Access Compliance Report

Public Rights-of-Way

Intersection ID: 54401	Main Street: LOMA_LINDA_LN	Cross Street: AVENAL_LN	Location: NW
ADA ID: 57F4BC3A85CC	Ramp Type: Perp	Initial Pass/Fail: Fail	Overall Compliance: No
		Severity Score: 8.75

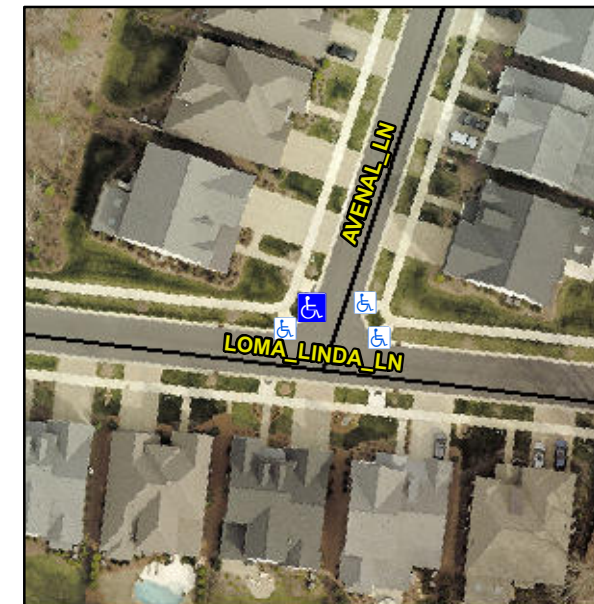
Not Found, R304.5.1

Compliance	Description	Data	Compliance	Description	Data
N/A	Ramp Length (in)	95.0	Yes	Ramp Slope (%)	7.7
No	Ramp Width (in)	47.5	Yes	Ramp XSlope (%)	0.2
N/A	Flare Type LT	N/A	N/A	Flare Type RT	N/A
N/A	Flare Slope LT (%)	N/A	N/A	Flare Slope RT (%)	N/A
N/A	Flare Traversable LT?	N/A	N/A	Flare Traversable RT?	N/A
N/A	Landing Length (in)	N/A	N/A	DWS Provided?	N/A
N/A	Landing Width (in)	N/A	N/A	DWS Contrast?	N/A
N/A	Landing Slope (%)	N/A	N/A	DWS Length (in)	N/A
N/A	Landing X Slope (%)	N/A	N/A	DWS Full Width?	N/A
N/A	Landing Curb? (Y/N)	N/A	N/A	DWS Offset (in)	N/A
N/A	Shared Landing?	N/A			
N/A	Gutter Ponding?	N/A	N/A	Gutter Slope (%)	N/A
N/A	Gutter Lip Ht (in)	N/A	N/A	Gutter X Slope (%)	N/A
N/A	Painted X Walk1?	No	N/A	Painted X Walk2?	N/A
	X Walk 1 Direction	To E		X Walk 2 Direction	N/A
N/A	X Walk 1 Width (in)	N/A	N/A	X Walk 2 Width (in)	N/A
	X Walk 1 Slope (%)	4.7		X Walk 2 Slope (%)	N/A
	X Walk 1 X Slope (%)	0.8		X Walk 2 X Slope (%)	N/A

Remove & Replace Entire Ramp.
